John Stacey

Further Submission dated 11/06/2026

Comments on EP4-151 Document: 6.13.A4 Environmental Statement Appendix 13.4 Residential Visual Amenity Assessment - Tracked Changes Version - Part 2

[REDACTED] (E8)

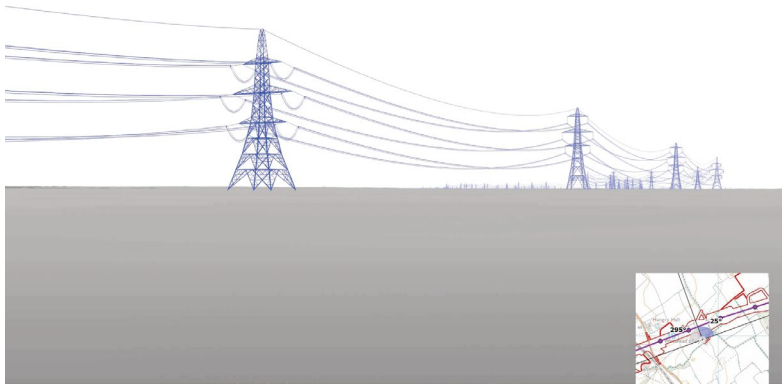
We await with interest the visualisation for the worst case scenarios and the visualisations in EP4-151 Document: 6.13.A4 Environmental Statement Appendix 13.4 Residential Visual Amenity Assessment are not acceptable.

The image presented on page 27 is wholly unrealistic:

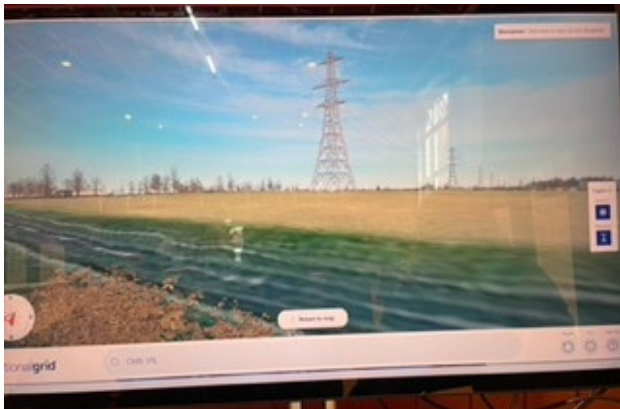
It suggests that it is possible to see approximately 80 pylons, with the furthest located more than 15 miles away. This does not present a realistic representation of the visual experience from the property.
